Sutton Beach Pavilion, Redcliffe

Structural Condition Audit Peer Review

Moreton Bay Regional Council

Project no. 7366

Figure 75: IMG_8644

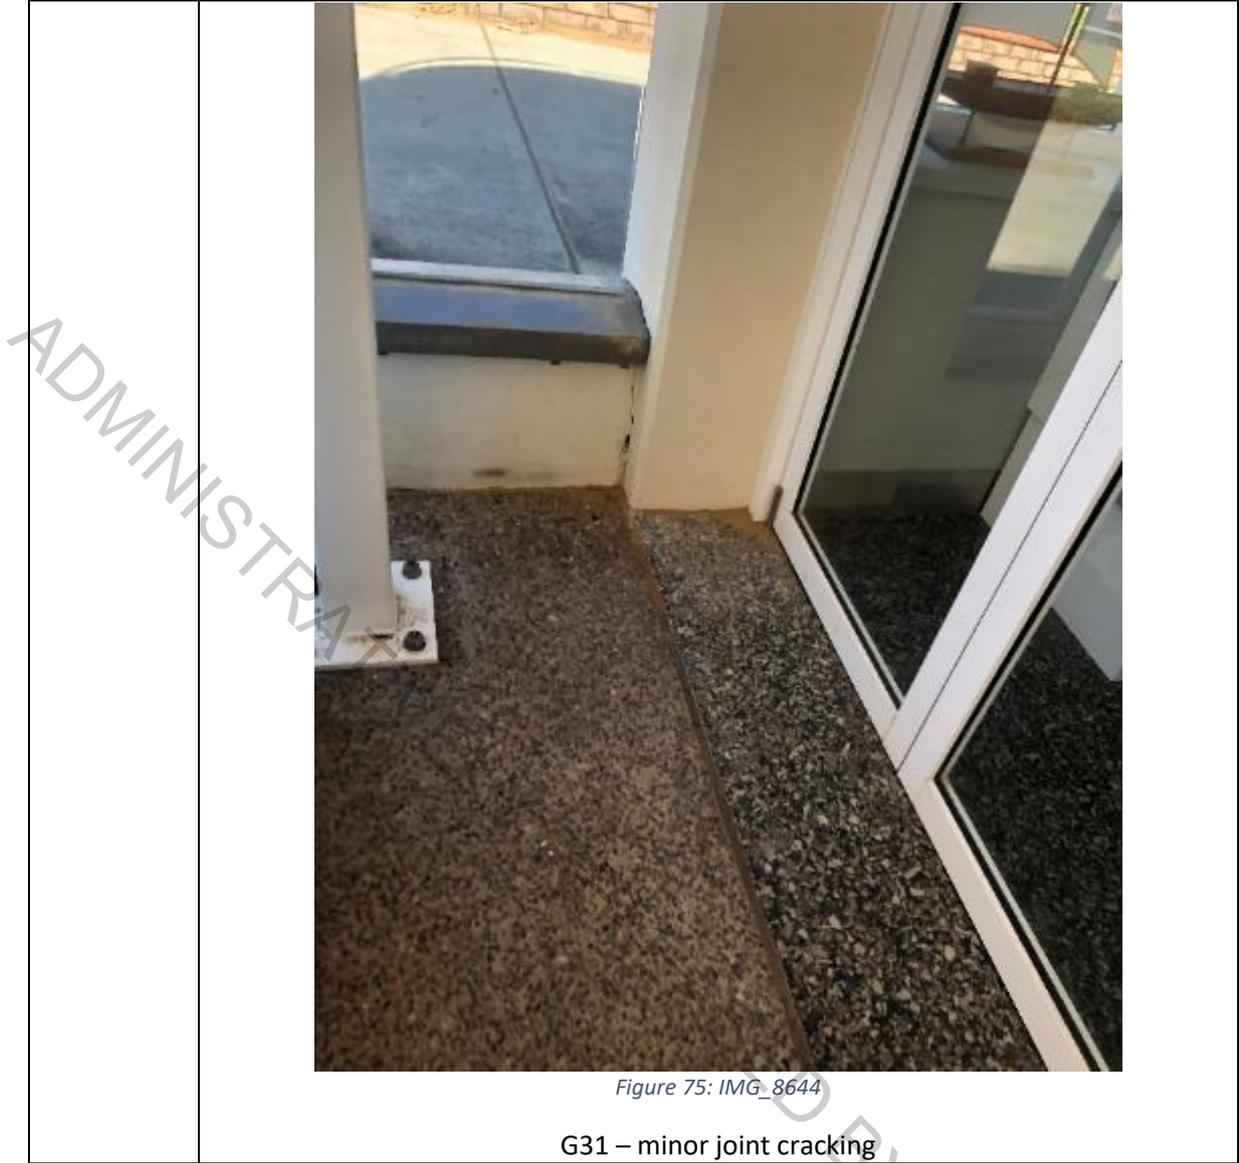
G31 - minor joint cracking
